MEMORANDUM

FROM: Thomas T. Burke, PhD, PE
Travis M. Parry, EI, CFM

SUBJECT: Park Corners II – Stormwater Management Design Summary
(CBBEL Project No. 04-389R142)

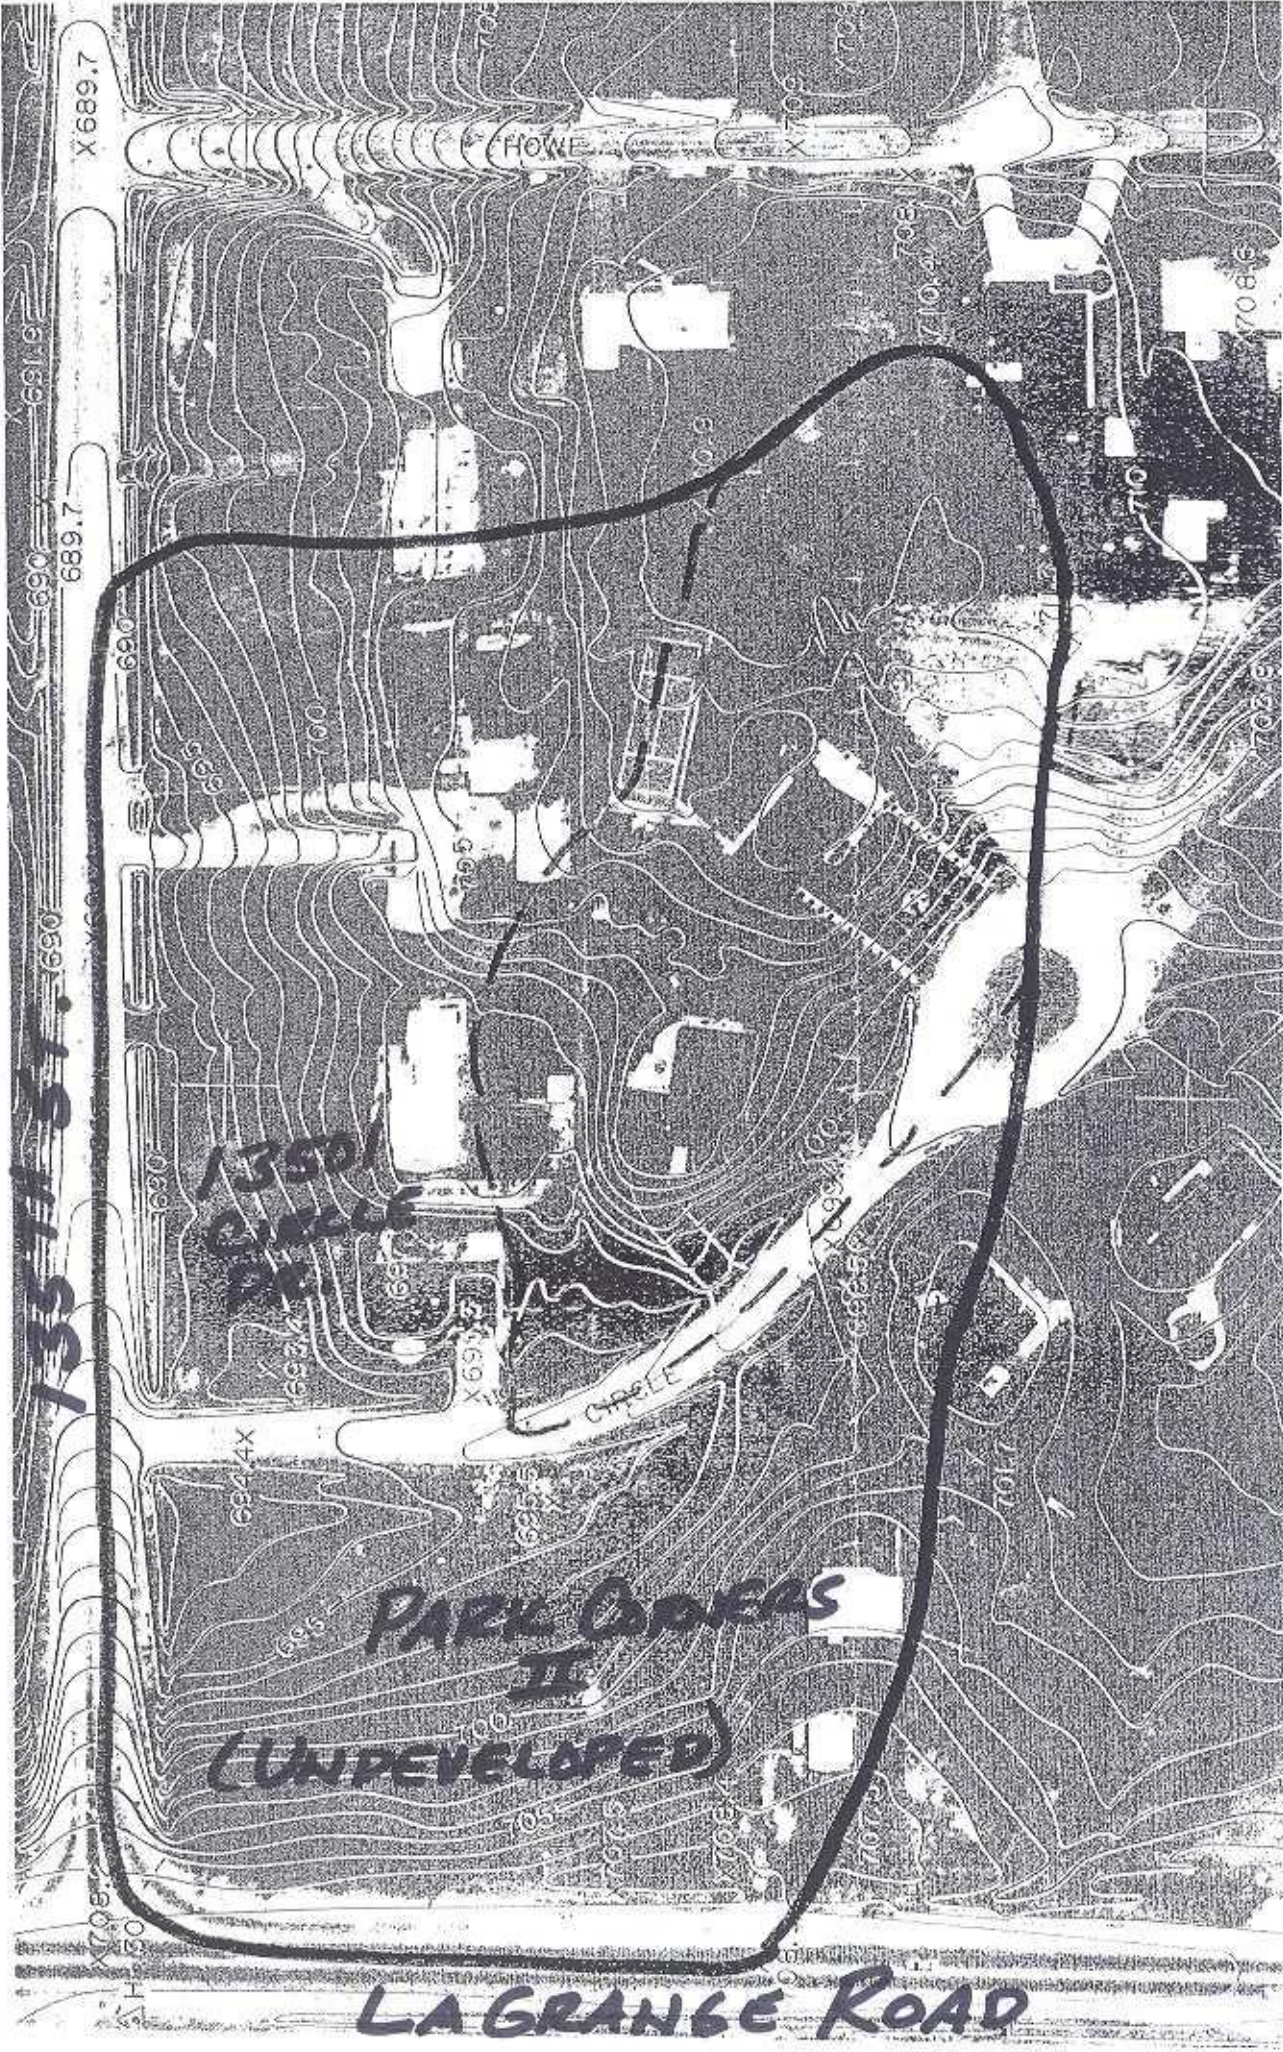
The Park Corners II project site is located within a sub-watershed of Mill Creek that is approximately 7.8 acres and is tributary to the 135th Street Right Of Way (ROW) under the jurisdiction of the CCHD. The sub-watershed is delineated on the attached exhibit from the Village's orthophotographic mapping. As shown, the 135th Street ROW ditch collects stormwater runoff from Circle Drive development to the south, from LaGrange Road to the west, from 135th Street to the north and the residential area to the east. In addition, the exhibit illustrates the undeveloped condition where a portion of the Park Corners II project site and LaGrange Road ROW drains directly to the 135th Street ROW and a portion flows overland across Circle Drive before heading north to the 135th Street ROW ditch. The LaGrange Road ROW and Park Corners II development site contribute approximately 14% of the total runoff from the 7.8 acre sub-watershed to the 135th Street ROW ditch.
